Regulation No. 94 (Frontal collision)

Proposal for Supplement 4 to the 01 series of amendments to Regulation No. 94

Submitted by the expert from the International Organization of Motor Vehicle Manufacturers*

Paragraph 6.2.1., amend to read:

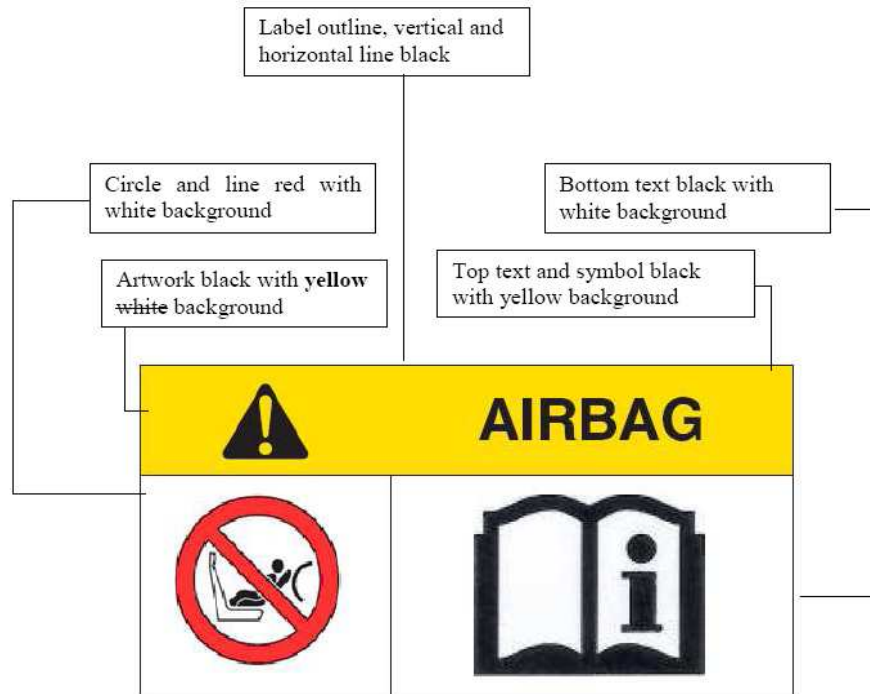
“6.2.1. As a minimum, this information shall consist of a label containing a pictogram and text warning, **an example of which is** as indicated below.

The overall dimensions shall be ~~120 x 60~~ **80 x 40** mm or the equivalent area, as a minimum.

The label shown above may be adapted in such a way that the layout differs from the example above; however, the text content shall meet the above prescriptions.”
